R E M A R K S

THE DRAWINGS

Amendments to the Drawings:

FIG. 1

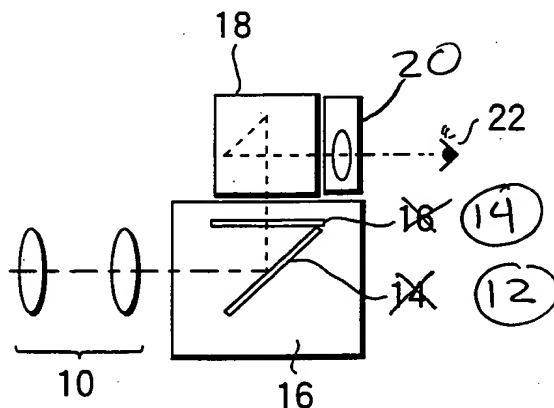
Fig. 1 has been amended as set forth hereinabove to correct the informalities pointed out by the Examiner.

Fig. 1 has been amended to change the first occurrence of reference numeral 16 to 14, to correctly designate the screen mat, in accordance with the description in the specification at page 7, line 19. In addition, Fig. 1 has been amended to change reference numeral 14 to 12, to correctly designate the mirror, in accordance with the description in the specification at page 7, line 18. Still further, Fig. 1 has been amended to add reference numeral 20 to designate the eyepiece optical system 20, in accordance with the description in the specification at page 7, line 20.
